DATE: June 10, 2014
TO: Sean Sullivan, JS Sullivan Development, LLC
FROM: Joy Navarrete, Planning Department
RE: PPA Case No. 2014.0562U for 469 Eddy Street

Preliminary Project Assessment

Date: June 10, 2014
Case No.: 2014.0562U
Project Address: 469 Eddy Street
Block/Lot: 0337/014A
Zoning: RC-4 (Residential – Commercial, High Density) Use District
North of Market Residential Special Use District
80-T Height and Bulk District
Area Plan: None
Project Sponsor: Sean Sullivan, JS Sullivan Development, LLC
415-206-1758
Staff Contact: Kansai Uchida – 415-575-9048
kansai.uchida@sfgov.org

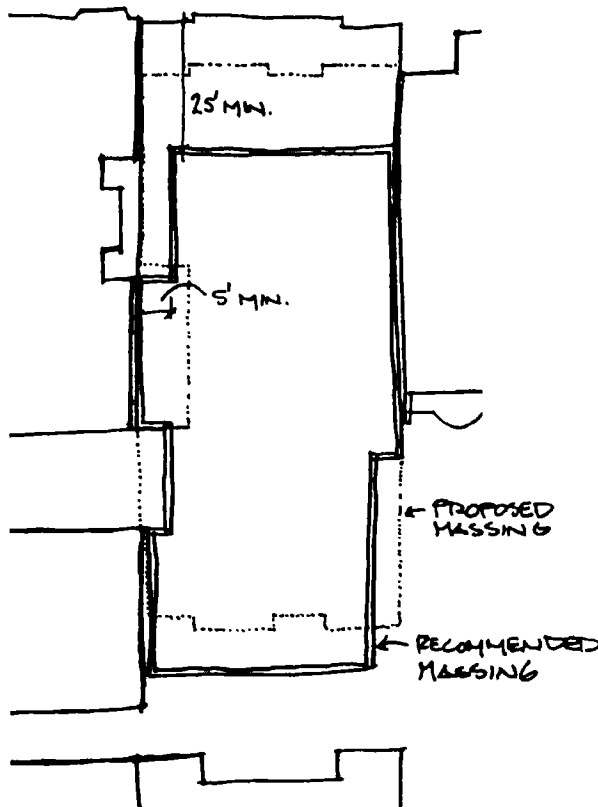
1. **Site Design, Open Space, and Massing.** The Planning Department recommends adjusting the massing of the project 1) to create a better relationship between it and the existing building as well as other buildings on the street frontage, and 2) to better respond to and accommodate the relationships between the building massing and open spaces at the rear, light well, and setbacks

The Planning Department recommends better integrating and preserving the existing historic resource to be more fundamentally a part of the project by setting the addition back a minimum 25'. The interior of the new structure should appropriately reuse or relate to the retained portion of the existing resource.

Re-configure the plan to minimize units that do not meet the exposure requirements.

Match the adjacent light well on the west side of the property to bring the west side of the property in a minimum of 5' to match the adjacent lightwell.

Additionally, the project should create a lightwell or notch at the back open notch of the westside property and could also create a reciprocal notch at the open space to the east. The Planning Department would support the rear wall moving back as long as exposure requirements are met either there or with the adjacent open space on the east side.

This plan diagram should help clarify the intent.

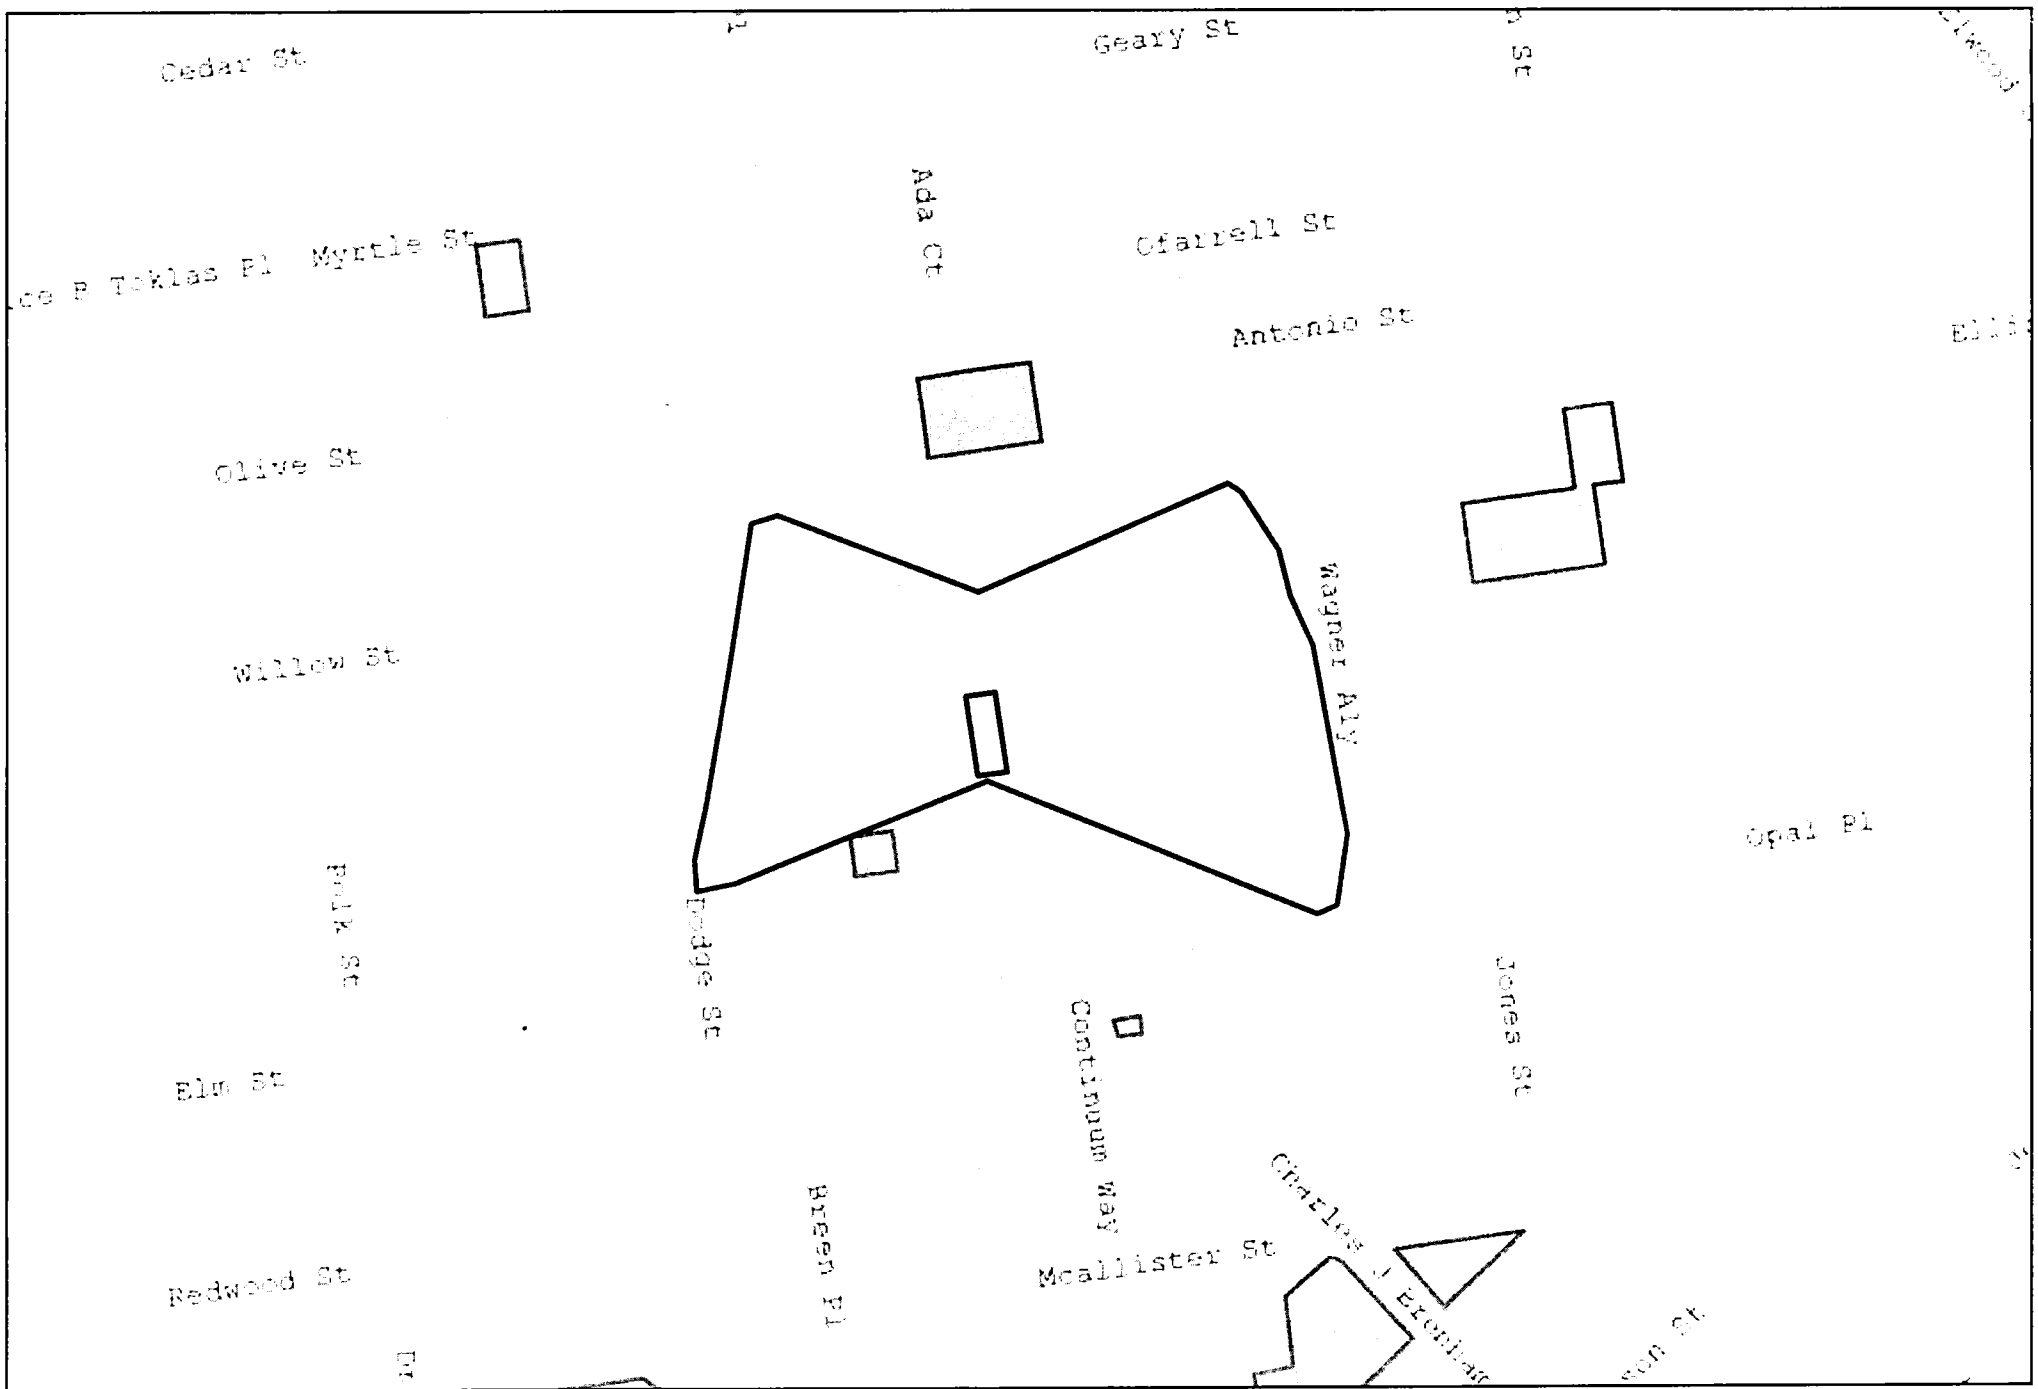
- a. **Composition and Style:** Existing buildings share a common tripartite vertical composition with defining architectural elements. The proposed addition design should respect the solid-to-void ratios of buildings within the District and incorporate compositional elements to break up the façade, including punched openings and introducing a strong horizontal element defining the top of the addition.

- b. **Massing:** Currently, the proposed design shows the addition setback 10 feet from the face of the existing façade with five stories rising above the existing two-story building and the existing second floor of the façade acting as a screen for patios for new residential units. Although buildings within the District range in height, the proposed massing overwhelms the existing building and inappropriately reuses the existing building façade. The setback and massing of the addition should more appropriately address the size and scale of the existing building. The Planning Department recommends setting the addition back 25-35 feet and reducing the overall height of the addition. Further, the front portion of the existing building should be retained as usable interior space at both the first and second floors.

- c. **Materials:** It is unclear what all the proposed building materials are. Please call out all materials, texture, and color of finishes including window and storefront system finishes proposed for the addition and rehabilitation of the existing façade. The addition should draw from the masonry material and texture typical of the existing building and Uptown Tenderloin Historic District.

- d. **Bay Windows:** The proposed arrangement of balconies does not complement the existing building and surrounding buildings, which have some regularity in pattern and are mostly symmetrical in layout. The proposed balconies appear to lack regularity in that they are located in alternating bays. The balconies and bay windows, if proposed, should be better integrated with a more complementary composition that draws on the patterns of bays and fire escapes on adjacent buildings within the District and that does not overwhelm the existing building.
